IES UTILITIES INC.

NG-94-2637 July 15, 1994

> Duane Arnold Energy Center Docket No: 50-331 Op. License No: DPR-49 Response to Request for Additional Information on Hydrogen Water Chemistry Relief Request 1) NRC Position on IGSCC in BWR Austenitic

Response to NRC Request for Additional Information

'A' 304(CU) ECP JAN'94

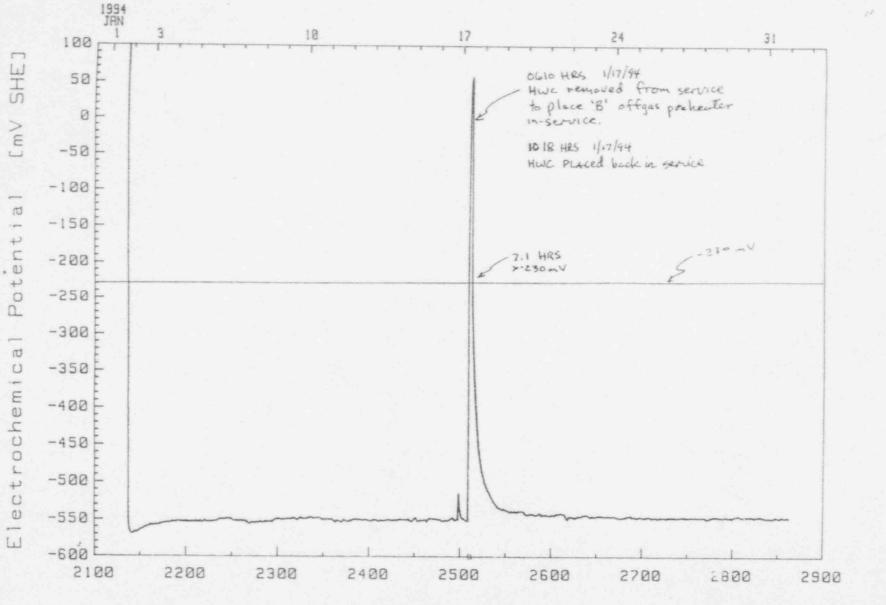
- a. Estimate the total hours in each fuel cycle when DAEC was operated with HWC and meeting the following conditions:
 - i) ECP lower than -230 mV
 - ii) Conductivity below 0.3 µS/cm
 - iii) Excluding all conductivity transients (>0.3 µS/cm) and hydrogen interruption transients

There have been no conductivity transients greater than 0.3 μ S/cm during hydrogen injection. If at any time ECP was above -230 mV, those hours were subtracted from the numerator when calculating availability. In other words, no credit was taken for the "memory effect" of hydrogen.

An example of how hydrogen interruption transients and availability calculations are done is shown below. It can be seen from the graph (Attachment 2) that HWC was >-230 mV for 7.1 hours during the month of January. Therefore, 7 hours is subtracted from the numerator and availability calculated.

Total Hrs in Month	= 744 Hrs
H ₂ Req'd to be on (>20% Pwr)	= 744 Hrs
Rx Recirc temp >200°F	= 744 Hrs
ECP Above -230mV (Bad)	= 7 Hrs
ECP Below -230mV (Good)	= 737 Hrs

Hrs <-230mV	737 Hrs
Availability BWROG =	and the set of the set and the set of the set.	= 99%
	Hrs >20% power	744 Hrs
